**COLLINS SUBDIVISION, FIRST ADDITION,**  
**RESUBDIVISION OF LOTS 17, 18, & 19**

APPLICATION NUMBER 22 DATE June 5, 2008

REQUEST Subdivision

# DETAIL SITE PLAN

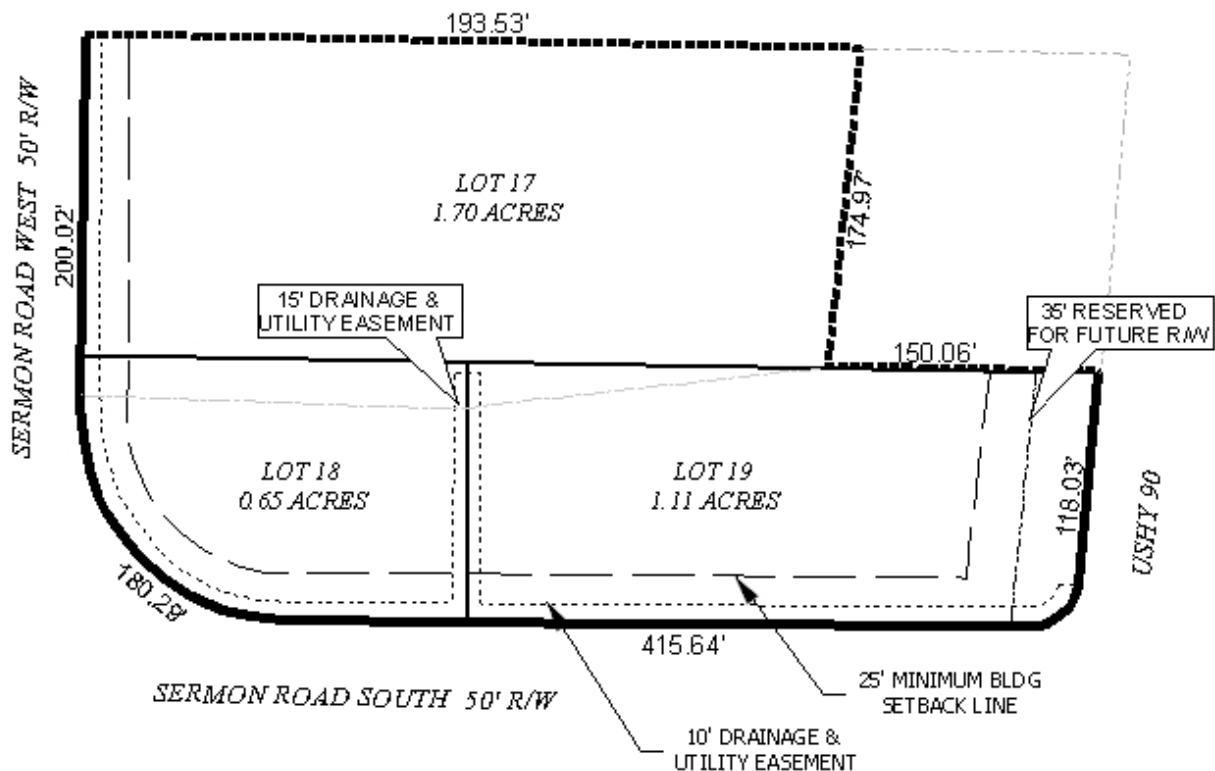
The site fronts onto U S 90, which is a major street. The right-of-way width at this location is not illustrated on the plat; however, the plat reflects a 35' reservation for future right-of-way and a 25' setback to allow for the future major street. For many reasons, the Planning Commission no longer requires "reservation", nor should a plat be sign with an area of reservation denoted. Therefore, this notation should be removed from the plat, and the setback from U S 90 be adjusted to 60' from the existing property line (150' from centerline).

Access management is a concern due given the frontage on U S 90, and proximity of the site to the I-10 interchange. If approved, Lot 19 should be denied access to U S 90, as was conditioned on the original approval in 2004.

- 3) labeling of the lot size in square feet on the plat, or provision of a table on the plat with the same information; and
- 4) placement of a note on the final plat stating that any lots which are developed commercially and adjoin residentially developed property shall provide a buffer in compliance with Section V.A.7. of the Subdivision Regulations;

- 5) placement of a note on the final plat stating that Lot 19 is denied curb cuts to U S Hwy 90;
- 6) the plat be modified to remove the depiction of a 35' reservation, and to illustrate a 60' setback (150' from centerline) from U S Hwy 90 (on Lot 19).
